MAJESTIC COMMERCENTER - PROJECT FRONTIER

SITE PLAN

MAJESTIC COMMERCENTER PROJECT
FRONTIER - SITE PLAN
GENERAL NOTES

PROJ NO: 240428
ENG: EAP/JLE
DATE: 12/11/2024

SP2

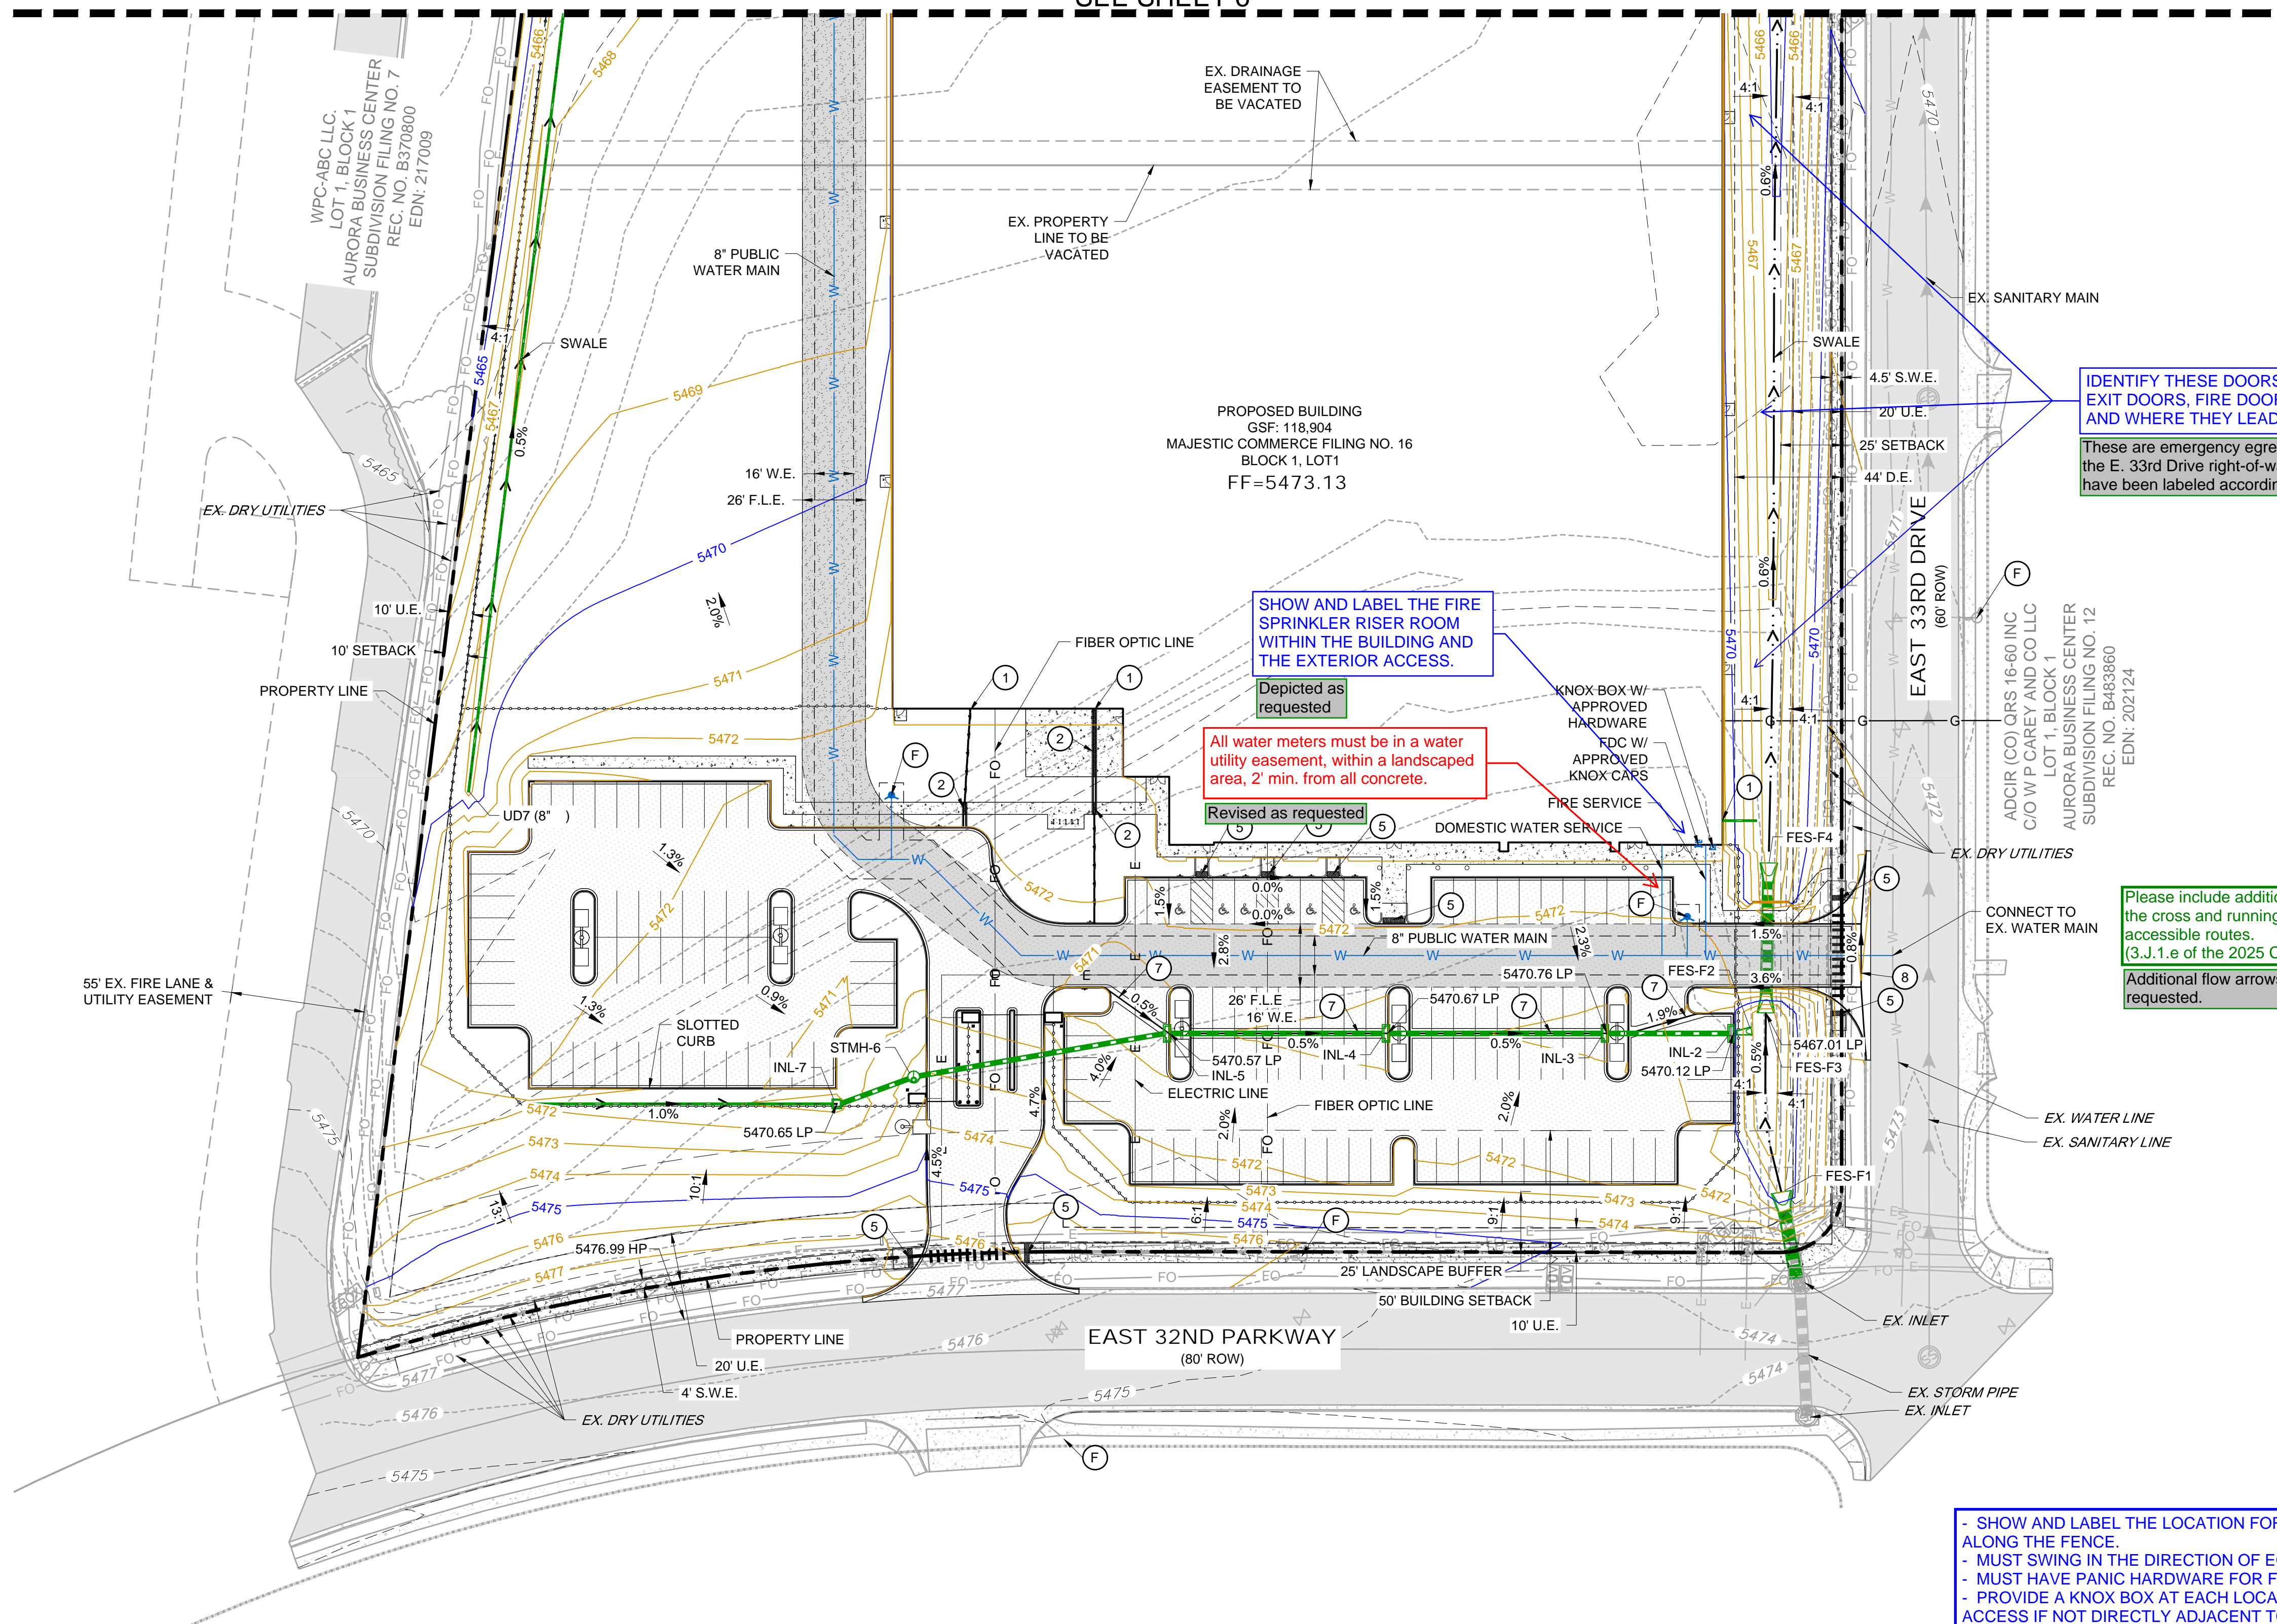
Please add the following notes:

need to
to a
40'.

Advisory comment: A sand/oil interceptor is required for vehicle maintenance facilities. (size and location to be include with building plans)

labeling the easements, since the legend linetype is the same.

Please fix, typ. all

We respectfully request an exception to the commercial access specification of a 40-foot width for the truck access on East 33rd Drive. The proposed width is necessary to accommodate the turning radii of large trucks (WB-67) and to ensure proper fit within the lanes for stacking. Included in this submittal are turning movement exhibits to support this request.

This has been illustrated in the utility plan

Easements called out within the plan sheet and legend has been modified accordingly.

Revised as requested.

SHEET DESCRIPTION
GP1
5 SHEET

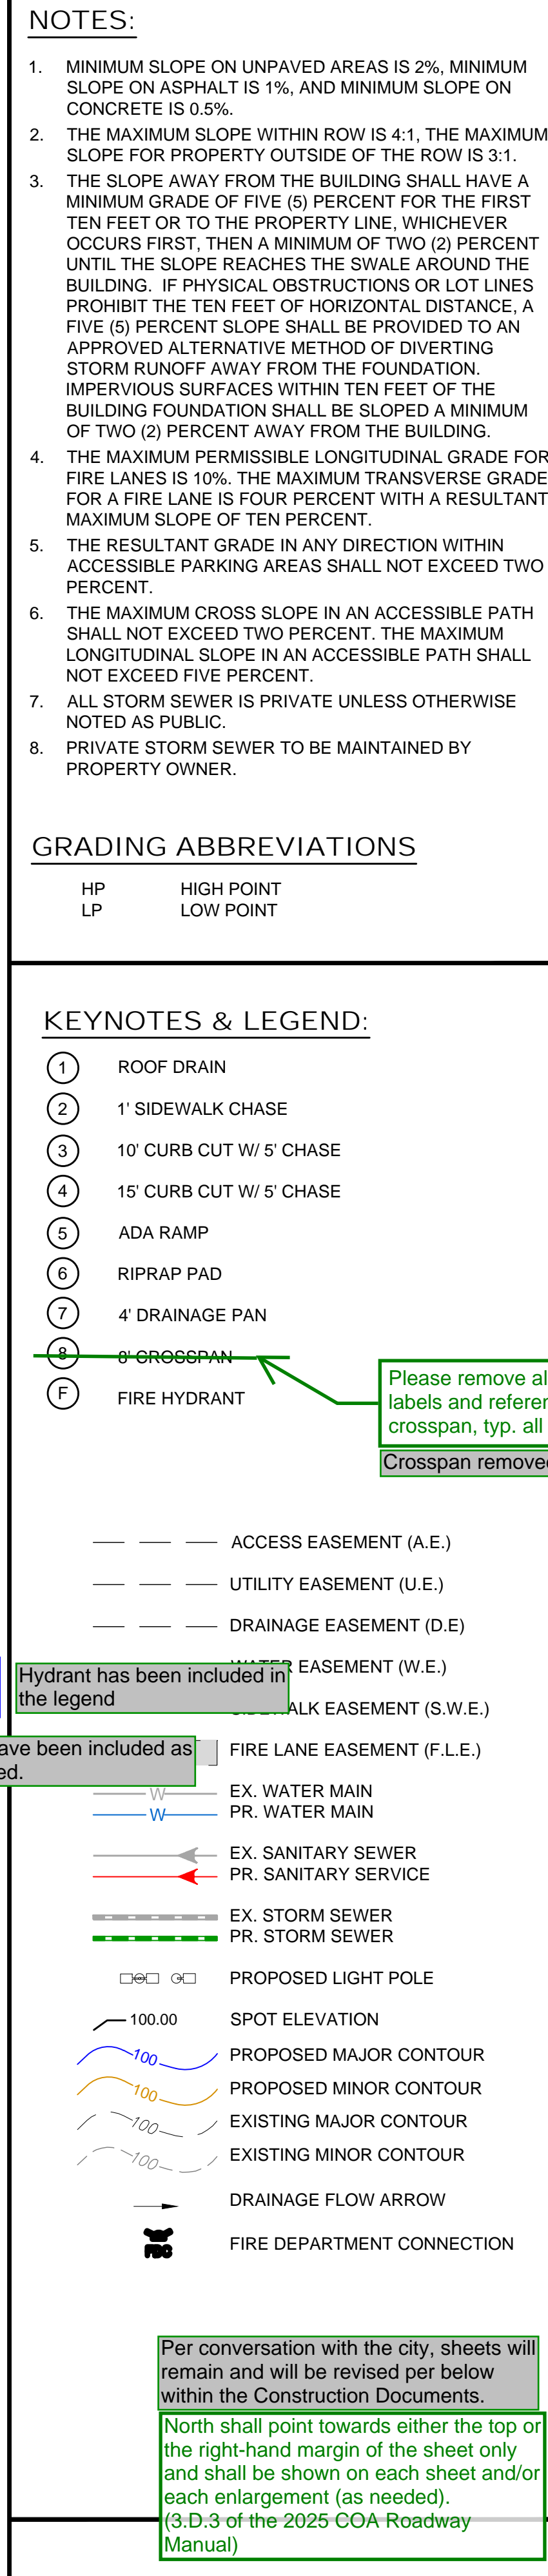
- SHOW AND LABEL THE LOCATION FOR ALL MAN GATES ALONG THE FENCE.
- MUST SWING IN THE DIRECTION OF EGRESS.
- MUST HAVE PANIC HARDWARE FOR FREE EGRESS.
- PROVIDE A KNOX BOX AT EACH LOCATION FOR FIRE ACCESS IF NOT DIRECTLY ADJACENT TO A VEHICLE GATE.

IDENTIFY THESE DOORS AS EXIT DOORS, FIRE DOORS, AND WHERE THEY LEAD TO.

SHOW AND LABEL THE FIRE SPRINKLER RISER ROOM WITHIN THE BUILDING AND THE EXTERIOR ACCESS.

All water meters must be in a water utility easement, within a landscaped area, 2' min. from all concrete.

Please include additional flow direction arrows, particularly for the cross and running slopes of the fire lane, accesses, and accessible routes.
(3.J.1.e of the 2025 COA Roadway Manual)

Please remove all crossspan labels and references to the crossspan, typ. all

Man gate near emergency access has been depicted and swing direction of egress

These are emergency egress doors to the E. 33rd Drive right-of-way and have been labeled accordingly

Depicted as requested

Revised as requested

Additional flow arrows added as requested.

Crossspan removed as requested

SHEET DESCRIPTION
L-1
SHEET 8

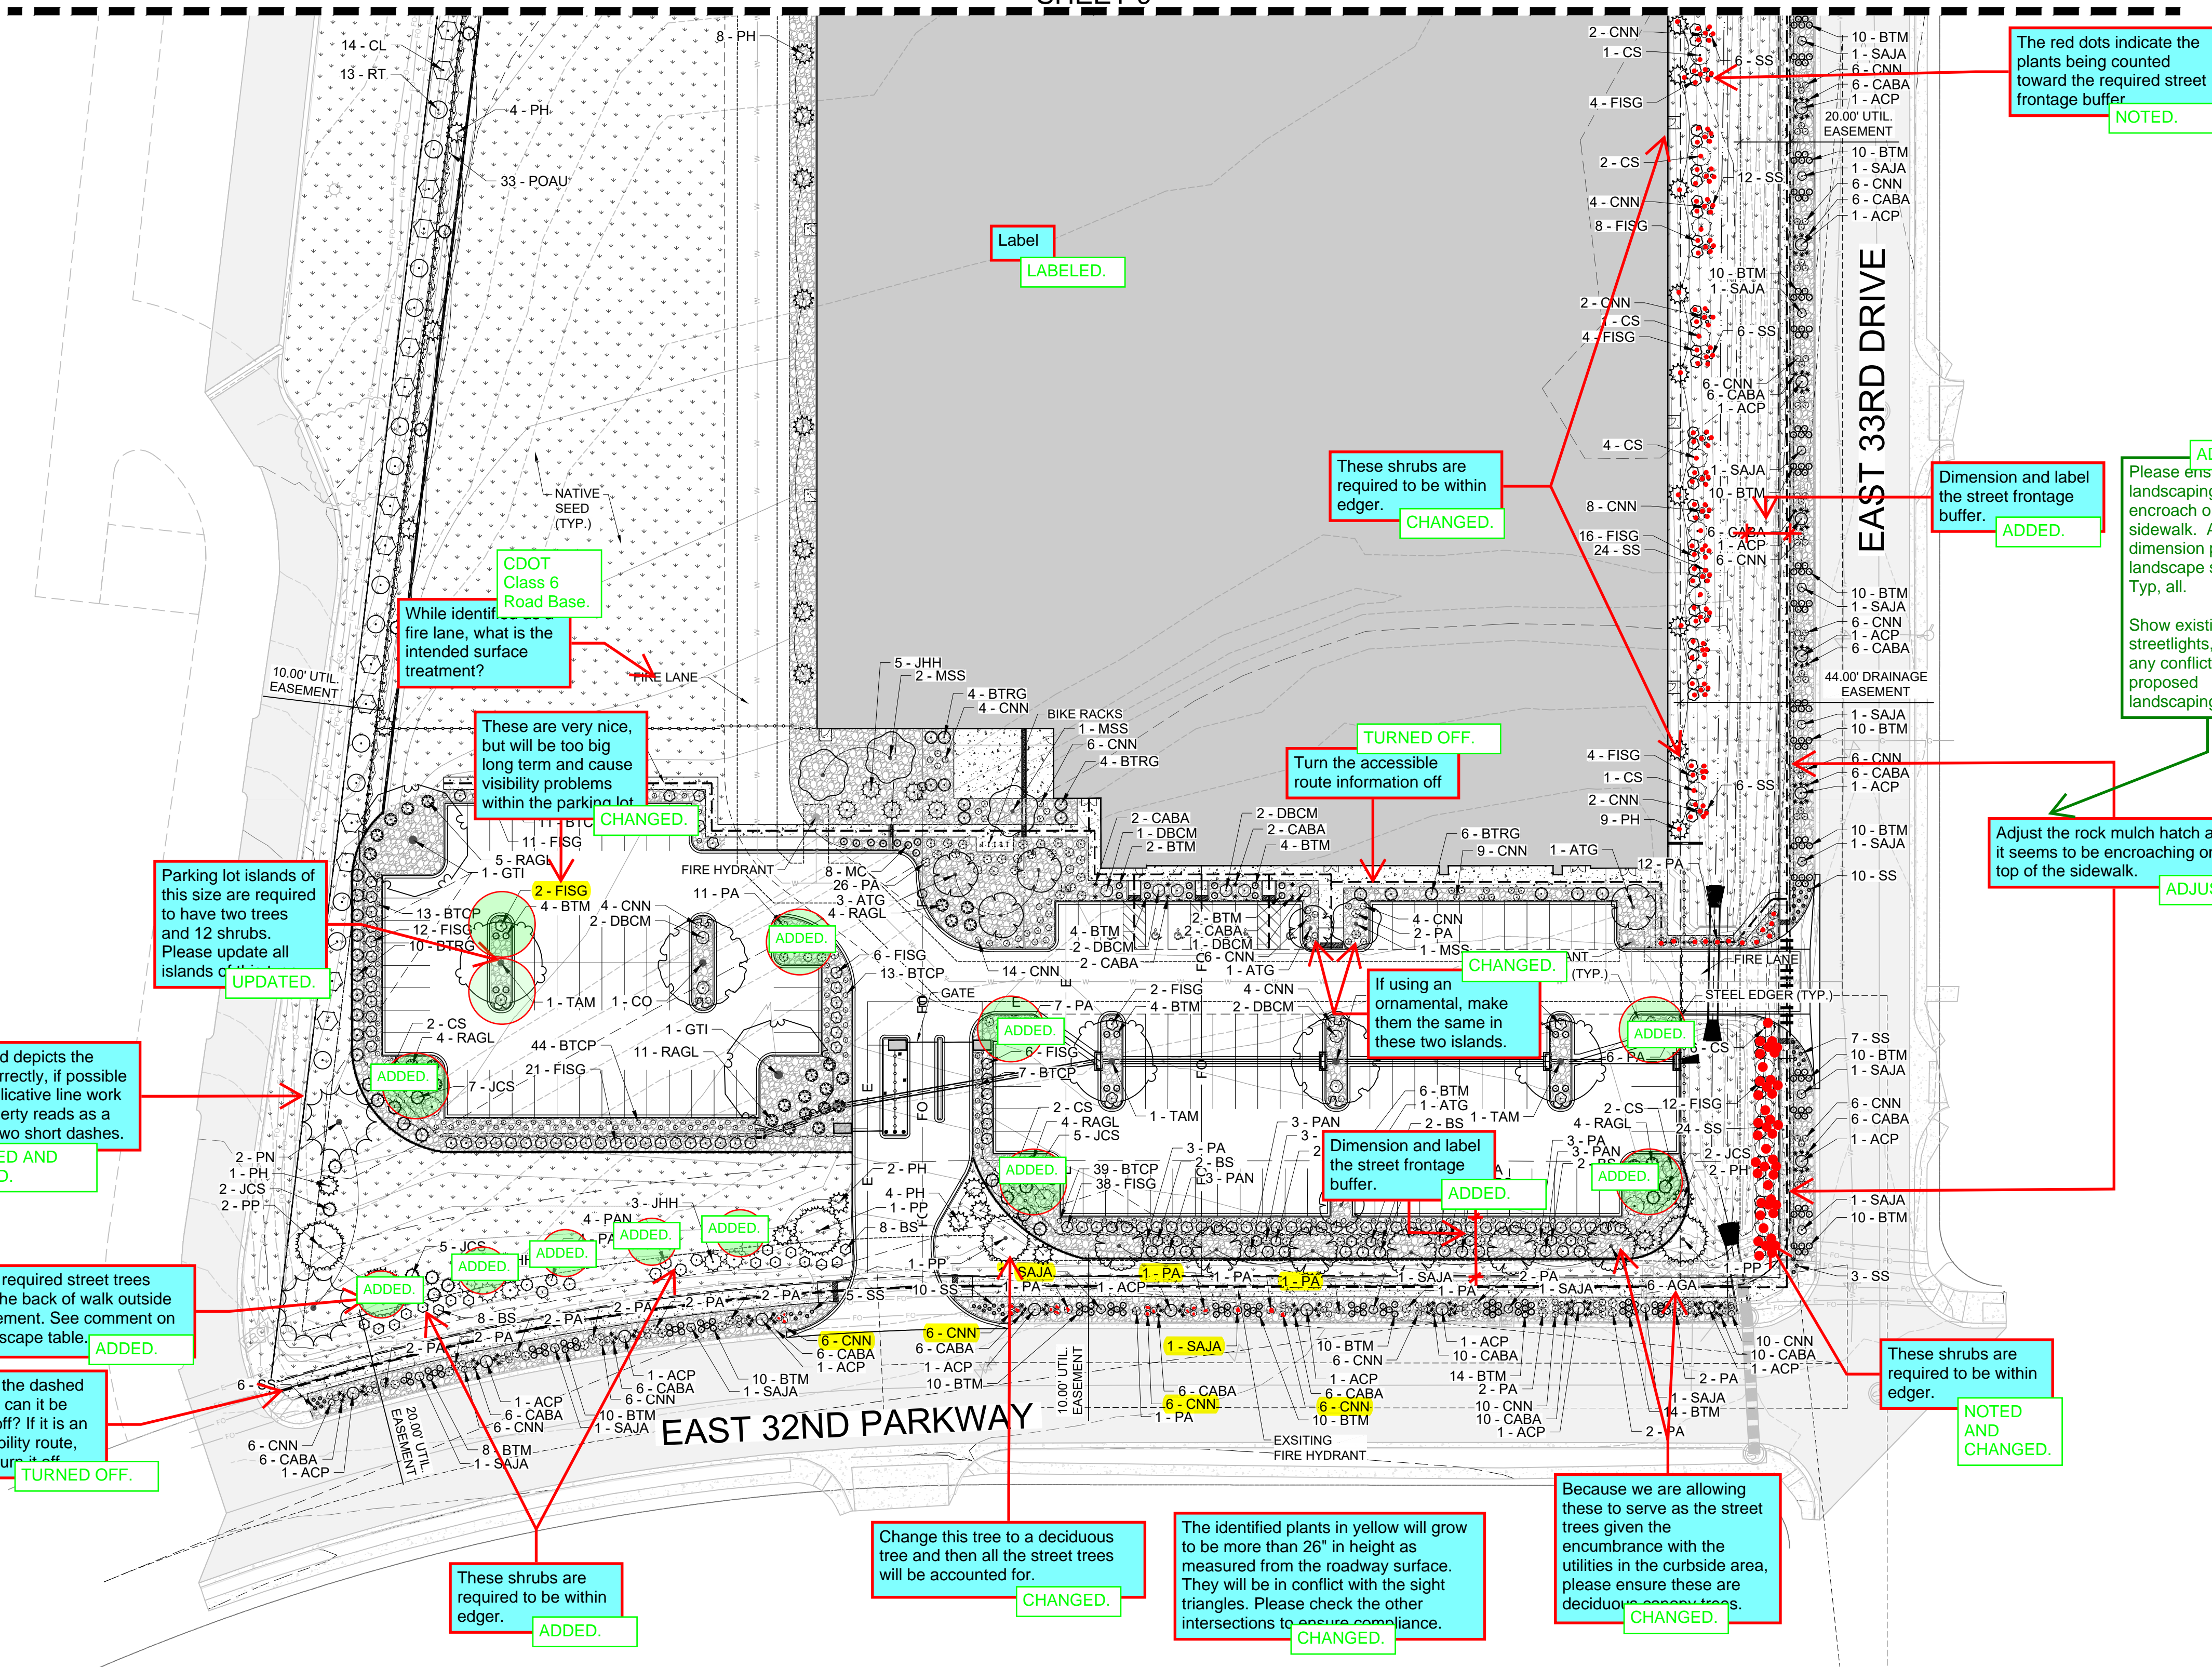
ADD NOTE:
All proposed landscaping within the sight triangle shall be in compliance with COA Roadway Specifications, Section 4.04.2.10

NOTE ADDED TO GENERAL NOTES ON SHEET D-1.
